Change the video output of GVN51 into RGB from composite

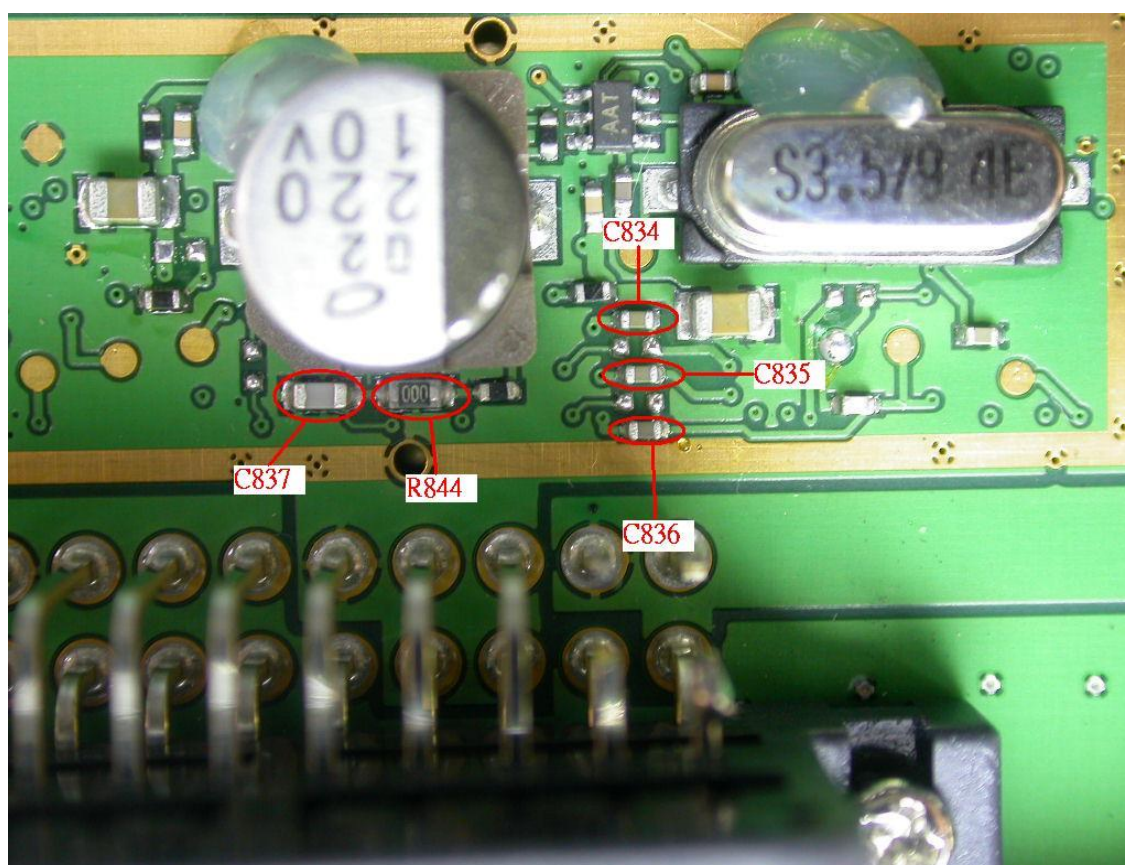
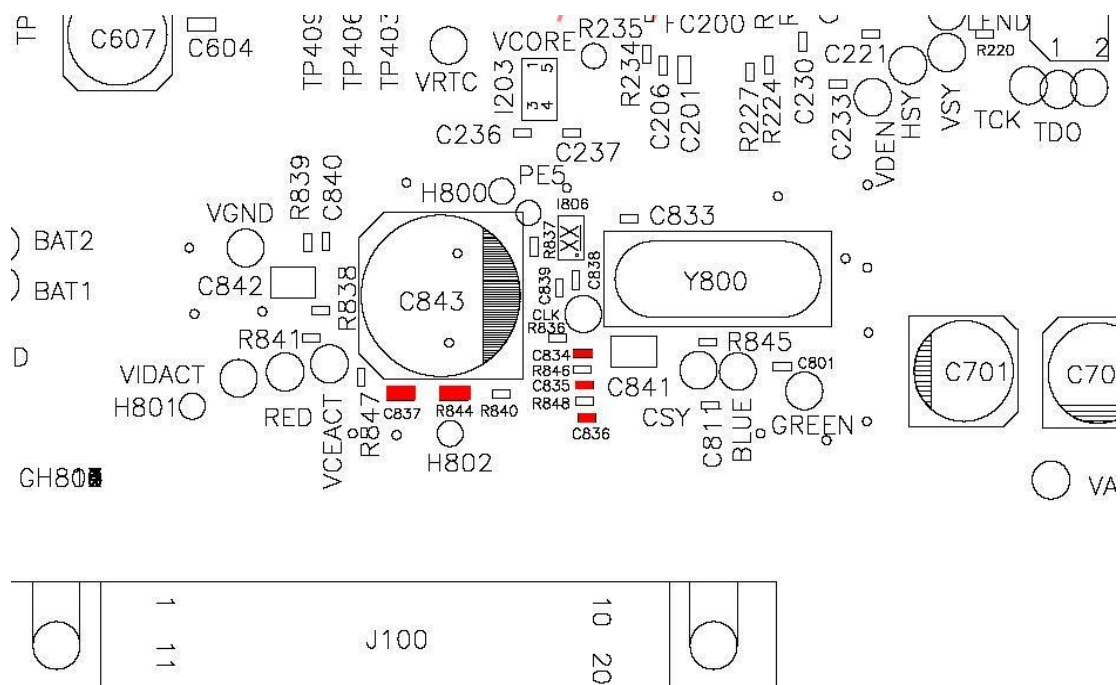
1.Remove C834,C835,C836,C837 and R844 from the board.

2. Place R845,R846,R847 and R848(907-00000-J0) in the board.
